Revisions and Errata List AISC Steel Design Guide 11, 2nd Edition, 1st printing (Printed and Digital Editions) August 20, 2020

The following list represents corrections made to the first printing (dated May 2016) and digital edition of the second edition of AISC Design Guide 11, *Vibrations of Steel-Framed Structural Systems Due to Human Activity*.

Fig. 7-17. Predicted FRF magnitudes, Example 7.2.

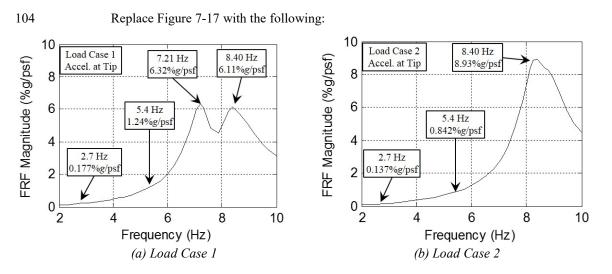
Replace the calculations with the following:

The peak acceleration due to the second harmonic is:

$$a_{p,2} = FRF(2f_{step})\alpha_2 w_p$$
(from Eq. 7-9)
= (1.24%g/psf)(0.05)(18.7 psf)
=1.16%g

The total peak acceleration, computed using the 1.5 power rule, Equation 7-10, is:
